TECHNICAL MEMORANDUM

GEOLOGIC AND GEOMORPHIC ASSESSMENT OF PERMANENTE CREEK, LEHIGH HANSON PERMANENTE QUARRY, SANTA CLARA COUNTY, CA

This technical memorandum provides the results of our geologic and geomorphic assessment of the Permanente Creek Restoration Plan – 90% Level Submittal, Waterways Consulting, Inc., dated 11/15/18 and updated 10/31/19 (the Project). The focus of the study was to determine if there were any specific areas of the proposed project which require further subsurface geotechnical exploration and testing to refine the project restoration design, so as to respond to comments dated February 14, 2019 from the County of Santa Clara Planning Office (“County”). Specifically, this work focused on a field assessment of the proposed alignment and longitudinal gradient of the proposed stream channel and how it compares to existing conditions. Particular attention was placed on the Rock Pile and Material Removal Area and the proposed depth of excavations required and stability of the adjacent creek sideslopes.

Figure 6: Profile of Material Removal Area from Station 152+50 to 132+50.

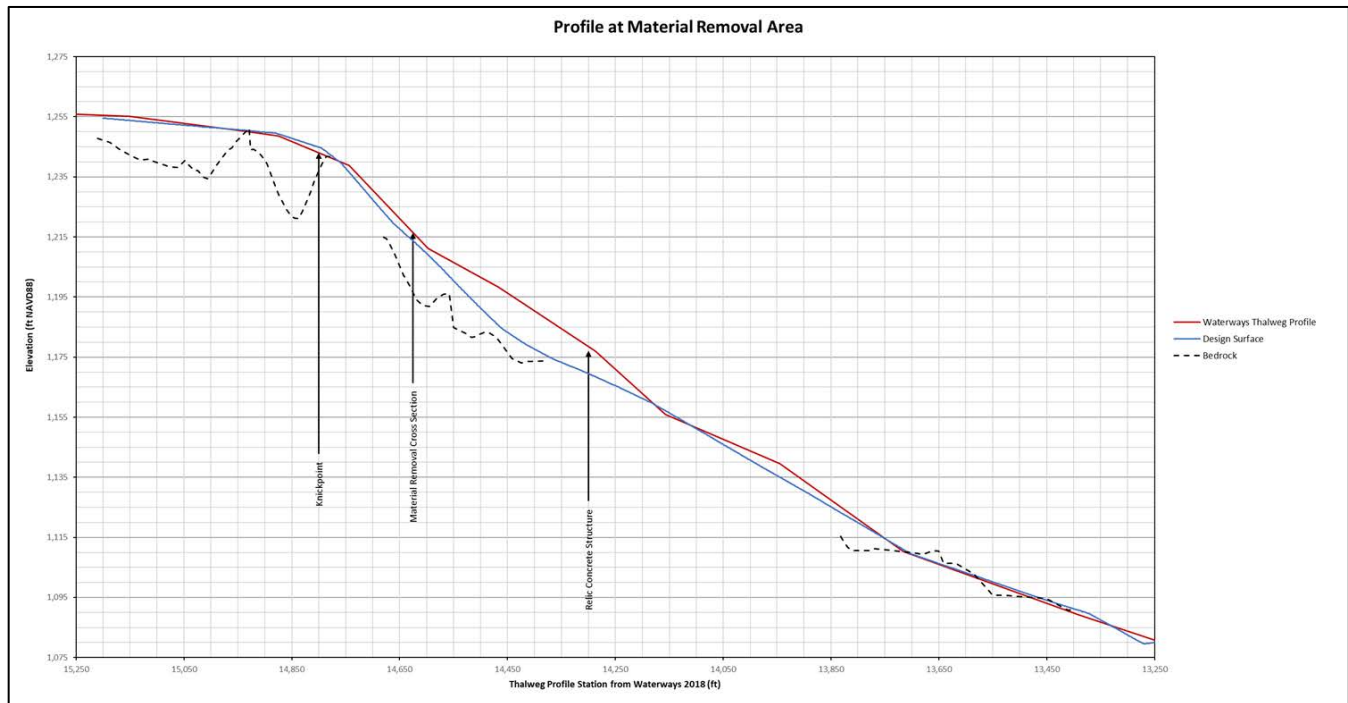
The following bullet points provide Golder's observations of the design as compared to conditions observed in the site reconnaissance and as informed by the seismic refraction survey data.

- At Station 148+00, bedrock close to the surface is likely the controlling feature of an upstream migrating knickpoint. The design shows the channel invert conforming to knickpoint and then potentially being established on exposed bedrock downstream of the knickpoint. We concur with this design approach. Additional design elements proposed including ESM and other profile control elements such as boulder weirs and sills should help to ensure stability of the knickpoint.

- Between Stations 146+50 and 142+50, the restoration design identifies a large quantity of material for removal from the channel. The relic mining infrastructure may play a role in defining the channel alignment and facilitating an armored surface on some of the debris. The result of the restoration efforts will increase the local gradient within this reach and extend the length of the high-gradient portion of the channel. Sheet C34 of the 2019 plan set provides additional details for Step-pool and cascade channel design segments in this reach to mitigate the local gradient. We concur with this approach and note that field engineering design modifications and follow on monitoring may be necessary to ensure that the post material removal channel geometry is stable.

- Between Stations 138+50 and 134+50, the seismic profiles indicate that bedrock may be encountered below design grade, but as the seismic profile lines were collected adjacent to the channel and not in the thalweg, Golder believes that bedrock may be exposed at relatively shallow depths along the thalweg. We understand that the intent of the design is to construct the channel on exposed bedrock

occurring within the proposed grading envelope and based on our reconnaissance we think this is generally achievable.

Figure 7: Typical Section of Potential MSE Wall to protect Water Treatment Facilities

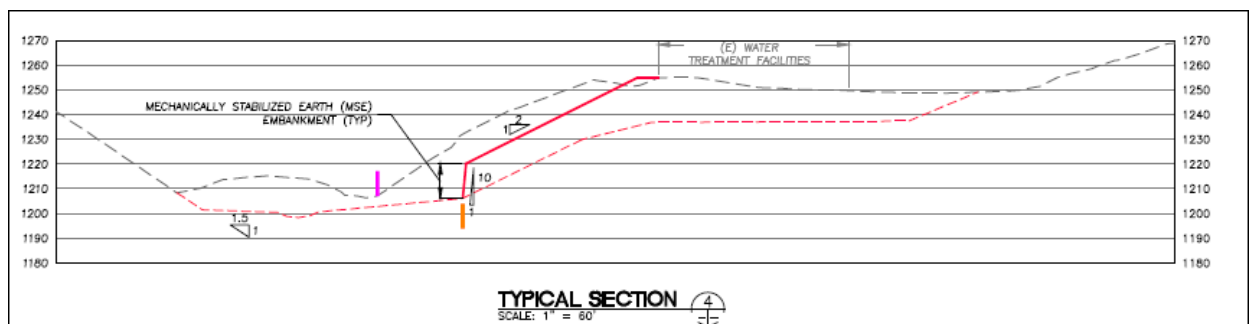
- The most challenging geologic and geotechnical issue in the Material Removal Area is the presence of the Upper Water Treatment System infrastructure, including the 1250 Pond and associated facilities located along the top of the creek bank and the access road to Permanente Creek. The lifetime of these facilities is uncertain at this time as they are required for on-going operations of the Facility. However, once reclamation is completed, they may no longer be necessary. If the facilities need to be protected during the creek restoration project, a retaining structure (e.g., Mechanically Stabilized Earth wall) will be necessary to maintain the road and the 1250 pond (as shown in Figure 4.0 of Waterways Updated Response Letter to the County dated 3-5-18 shown below). The retaining structure would be required as the design calls for pushing the north bank of the creek approximately 25 further north than current conditions.

- If a retaining structure is required, Golder recommends that a geotechnical investigation be performed along the alignment of the wall to verify depth to bedrock and to obtain appropriate design parameters for the design of the wall. However, depending on the timing of the restoration project, a retaining structure may not be necessary and therefore we recommend delaying any further investigation until such time it is needed. Figure 8 illustrates the design surface and bedrock conditions if the slope can be graded back at 2H:1V. This slope configuration meets Golder's general recommendations for cut slopes developed in surficial materials and is considered acceptable.

Figure 8: Cross section at Material Removal Area. Located at Thalweg Profile Station 146+00. Note depth to bedrock is approximate and estimated based on seismic refraction data.

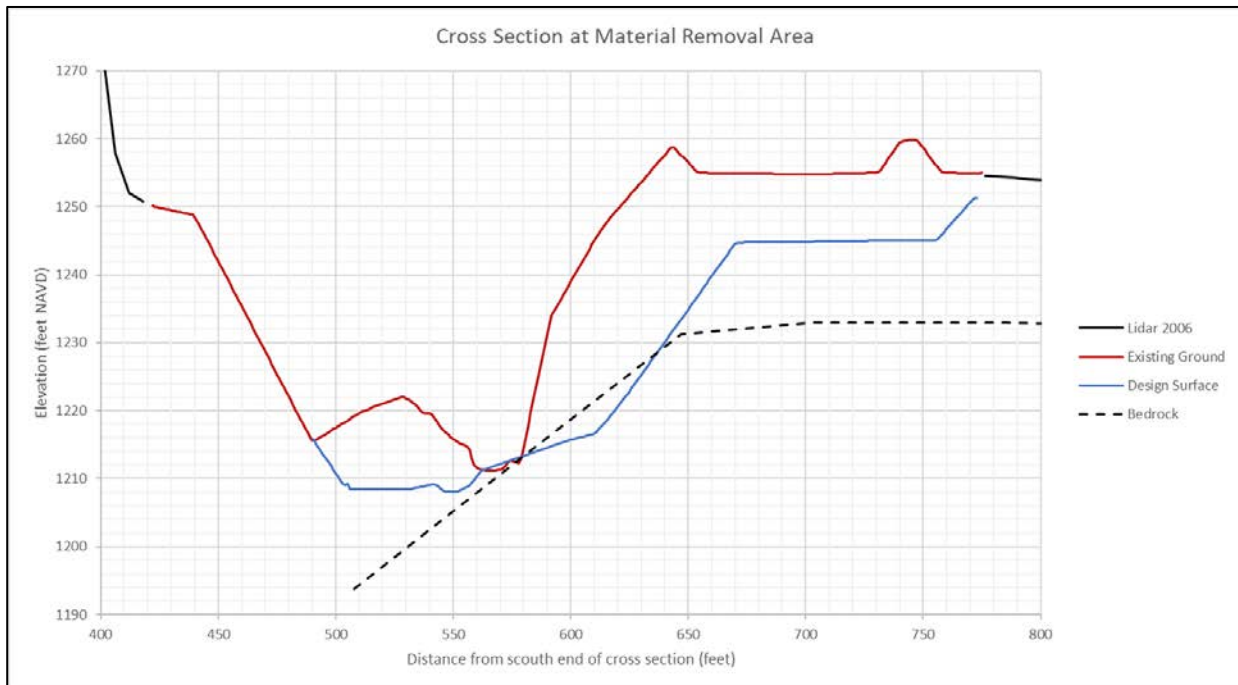
A geologic and a geomorphic map of the Material Removal Area is presented in Figure 5. Longitudinal and thalweg profiles of this area are presented in Figures 6, 7 and 8. In general, both the cross section and long profile indicate that bedrock is close to the surface throughout the Material Removal Area with the exception of a few local areas where depths may be in the range of 15 to 20 ft bgs. The design approach used by Waterways notes that the estimated bedrock contacts as shown are approximate, and that the design will allow for the work to conform to and follow the bedrock surface as it uncovered during excavation.¹ Golder concurs with this general approach and doesn't believe any additional exploration would provide value to the design above and beyond the data provided by the seismic refraction surveys.

Figure 10: Profile of Rock Pile Area from Station 104+50 to 84+50.

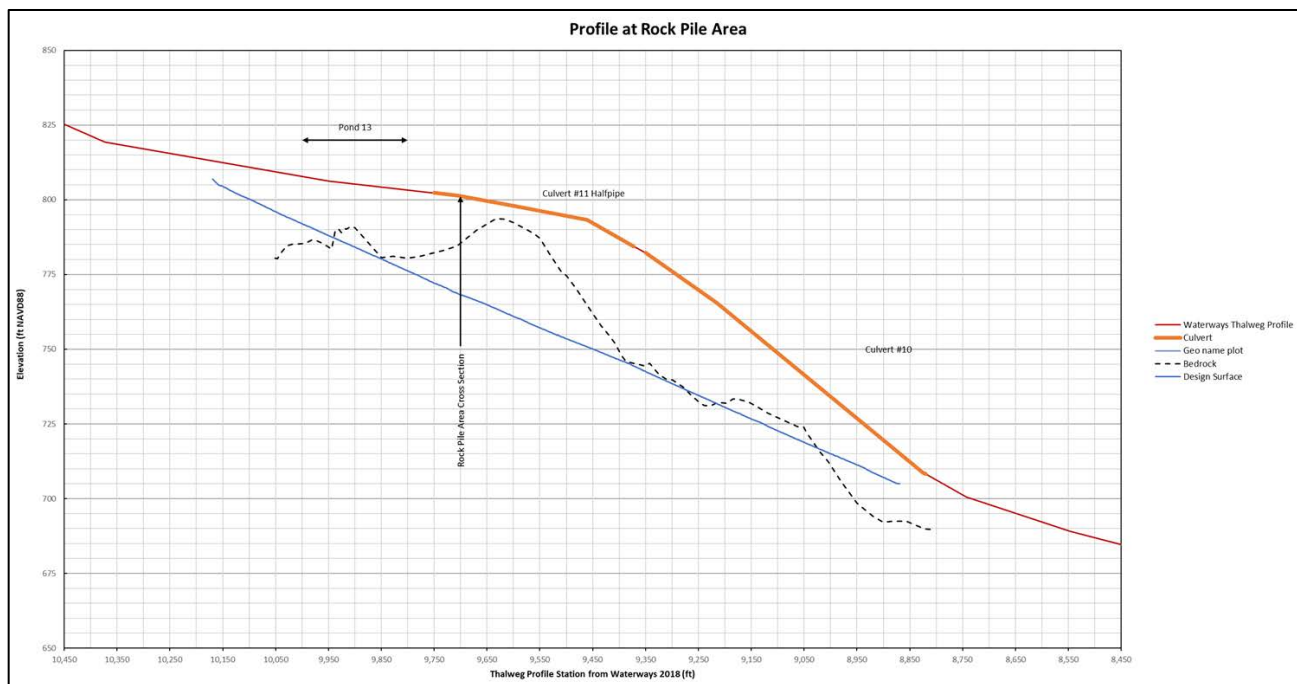
- The bedrock surface depicted on Figure 10 is close to the "Upper Limit of Potential Design Channel Invert" as defined by Waterways (based on seismic lines and verification borings), whereas the grading plan included on the design drawings represents the "Lower Limit of Potential Design Channel Invert" to show the maximum extent of potential grading. It is our opinion based on the review of available data that the constructed profile will be close to the "Upper Limit" upstream of Rock Pile Design. In summary, it is our opinion that the design is reasonable, and additional exploration will not provide value to the design above and beyond the data provided by the seismic refraction surveys and previous completed borings.

Figure 11: Cross section at the Rock Pile Area. Located at Thalweg Profile Station 97+00.

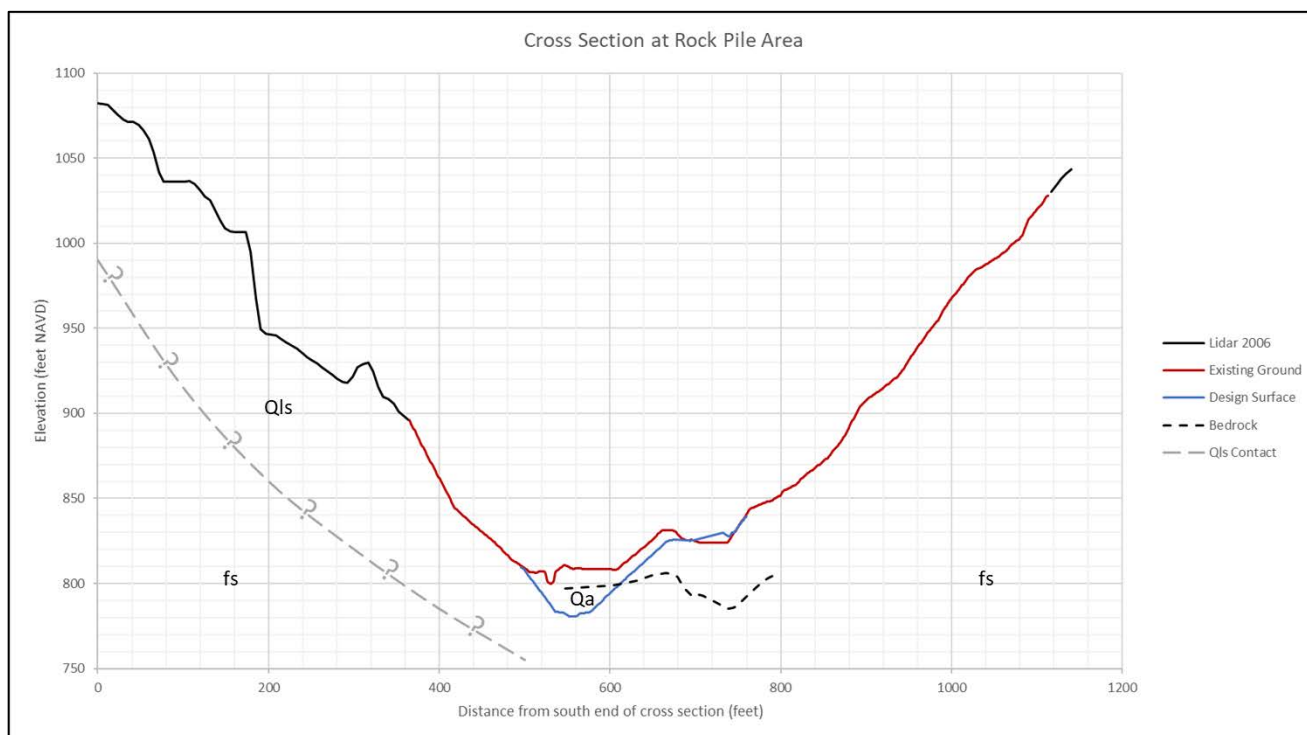
- The seismic data also identifies a potential former bedrock channel, which extends through the Rock Pile Area that in some locations is north of the proposed thalweg (Figure 11). Golder understands that Waterways has, to the extent possible, re-occupied the historic thalweg; however, extensive grading would be required in some areas to realign the channel and move it further to the north to occupy the historic channel thalweg. We understand that pushing the toe of the slope further north is not considered feasible given that this would require significant flattening of the slope which would impact the extensive infrastructure located at the top of slope including the main access road and the crusher facility. Golder recommends that field engineering design modifications be applied to utilize existing

bedrock topography and historic thalweg to the extent possible to meet the desired restoration outcomes.
